PLANNING & ENVIRONMENTAL PROTECTION COMMITTEE

TUESDAY 23 FEBRUARY 2010 AT 1.30PM

UPDATE REPORT & ADDITIONAL INFORMATION

PETERBOROUGH CITY COUNCIL

This is the view from the driveway of 19 Old Leicester road, halfway round the bend for a driver coming out of Wansford and is 30 meters from the driveway of the proposed building plot.

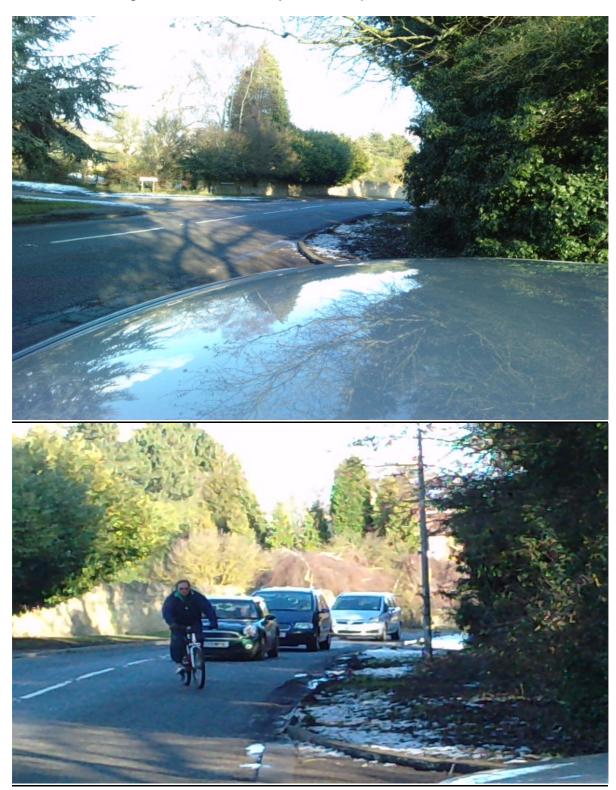
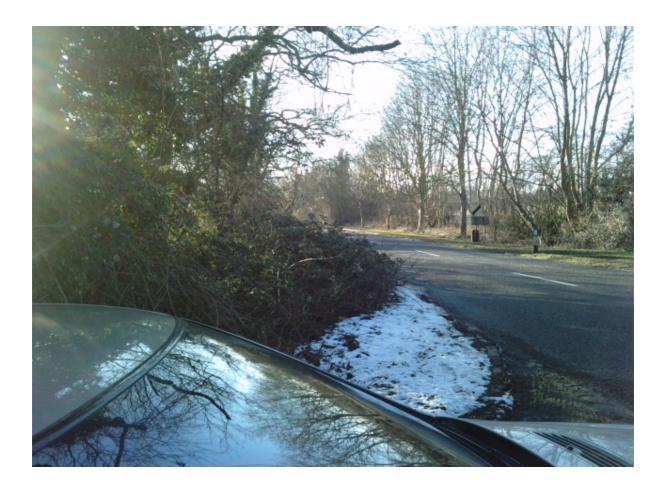
- No view at all unless the driver drives into the middle of the road.
- The hedge would have to be cut back to give any sort of view.

- No view of oncoming traffic until the nose of the car is halfway over the road.
- The hedging would have to be severely cut back and an element of traffic calming would have to be installed in order to make this a safe entrance and exit.
